Sadma Fashion Wear Ltd. (Extension)

4th October 2021

Observations

Beam layout at 1st & 2nd floor

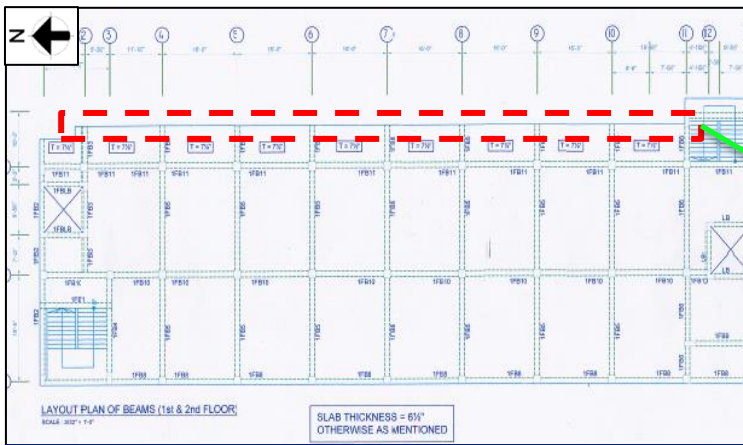
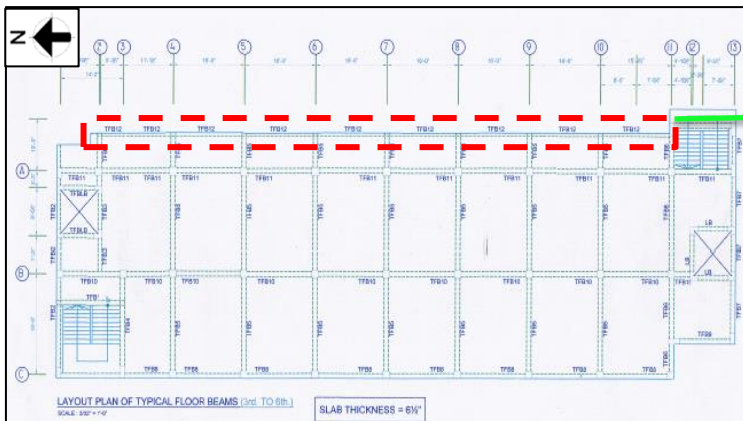
No beam along longitudinal direction has been shown on cantilever part at 1st & 2nd floor in beam layout. But a beam has been found on-site measuring width 250mm & d/s= 450mm.

Beam layout have been found mismatched with as-built drawing. Factory engineer is required to update the as-built drawing with accurate on-site condition.

Beam layout at 3rd to roof floor

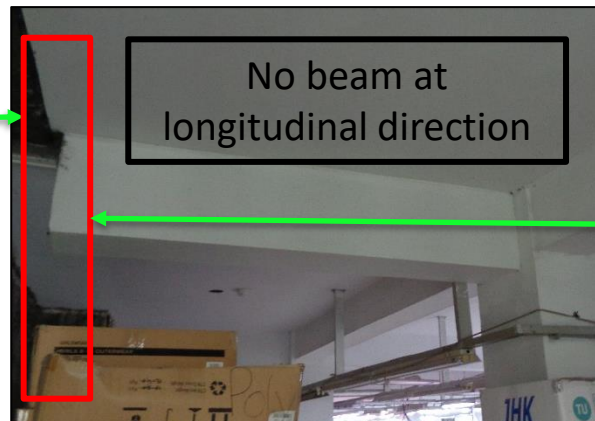
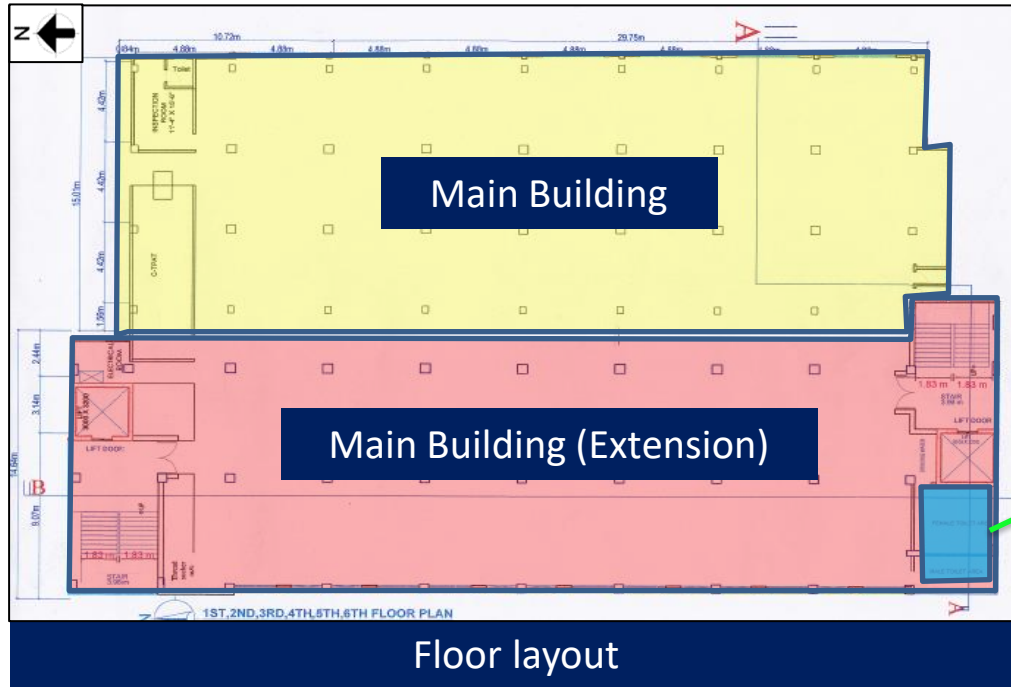
A beam (250mm X d/s = 400mm) along longitudinal direction has been shown on cantilever part from 3rd to roof floor. But no beam has been found on-site.

Floor layout

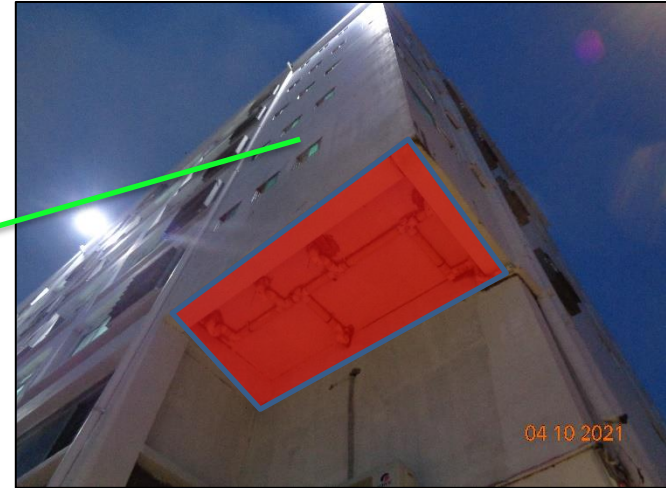
Build-up was found on toilet zone approximately 100mm which is not mentioned in as-built drawing. Factory engineer is required to update the as-built drawing with accurate on-site condition.

No design report for utility building

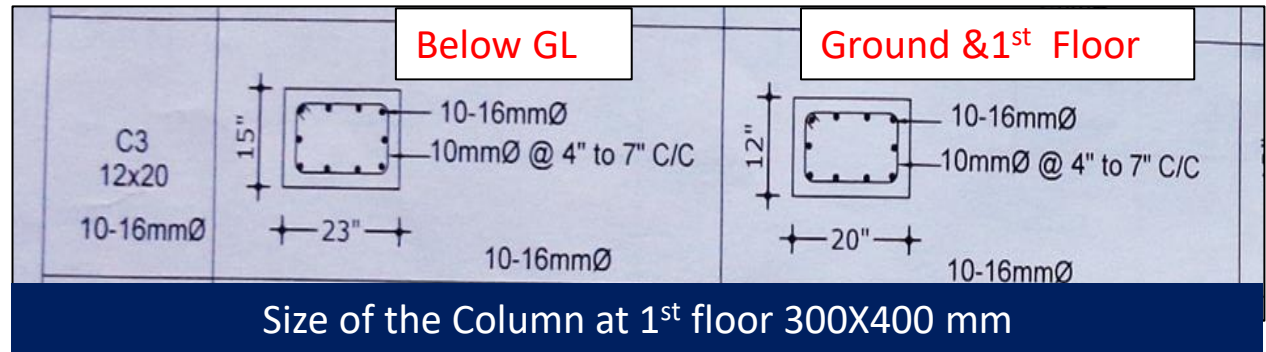
As per BNBC, every building or structure designed shall have its design documents prepared in accordance with the provision of Section 1.9.1. The design document shall include a design report, and a set of structural drawings, which shall be prepared in compliance with section 1.9.1.1 and section 1.9.1.2 as per BNBC (Part-6). Factory provided only as-built drawing for this structure, but no design report was available at the time of inspection.

Factory engineer is required to prepare design documents including design report, load plan following BNBC-2006 requirements.

Size of the Column was measured 375X575mm

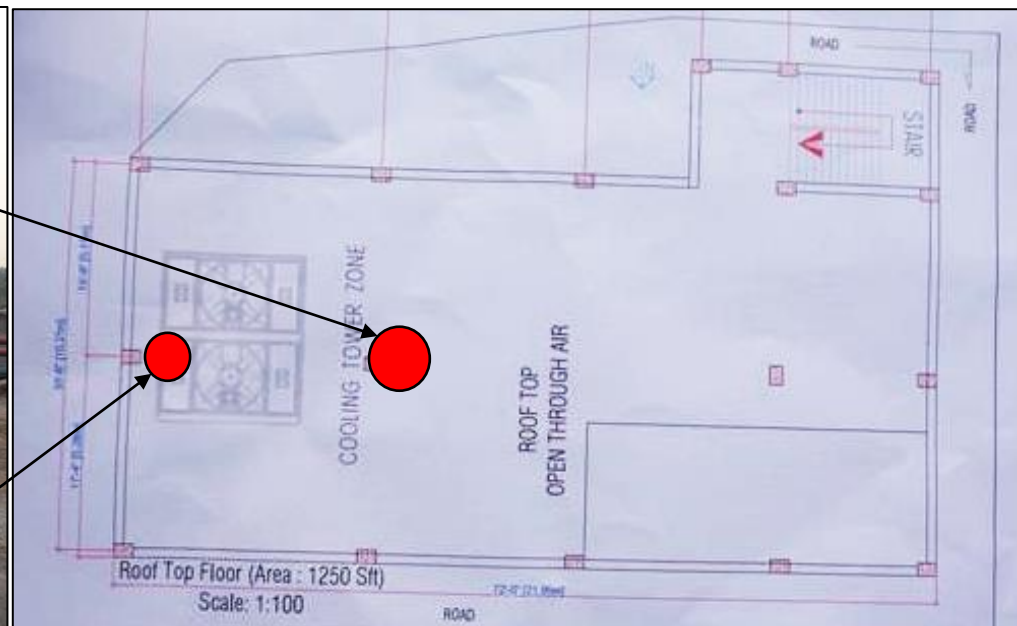
Ground floor columns are 5.55 m in length and 375X575 mm in size. The length/width=14.8 indicates that the columns are critical for slenderness effect.
So, the factory engineer is required to check and address this issue in the design report.

Roof Layout plan

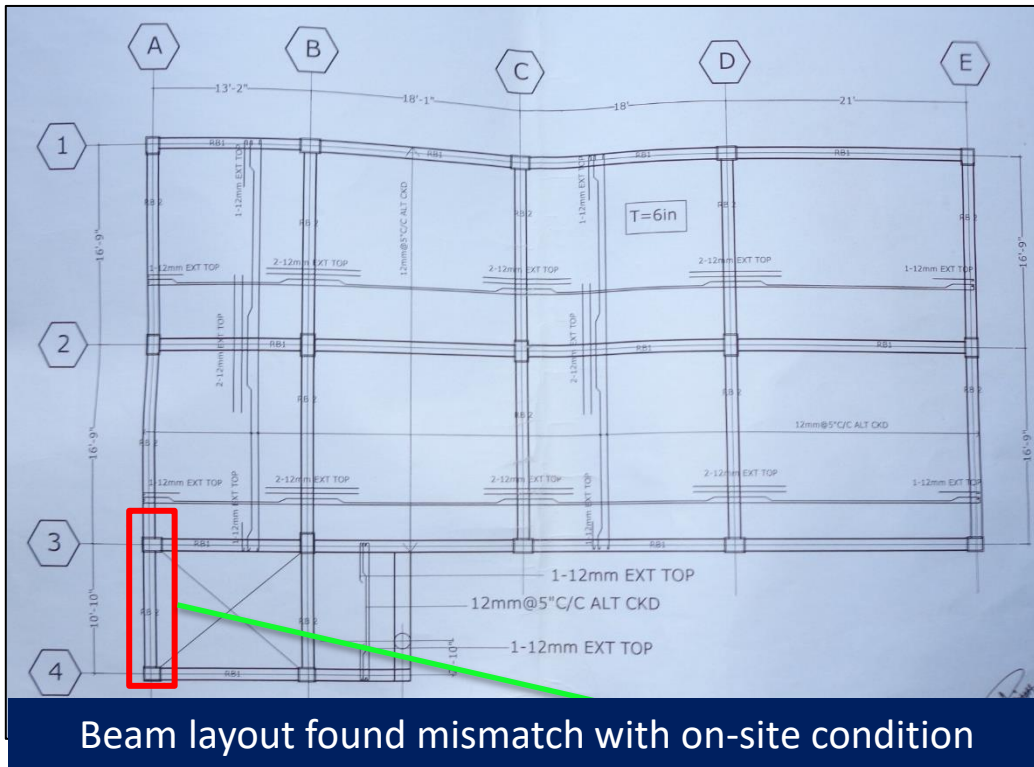
Undocumented water tank was found at roof. One 5000 L and one 500 L water tank water was found roof with build up which has not been shown in drawing.
Factory engineer is required to survey the whole structures and update the as-built drawings.
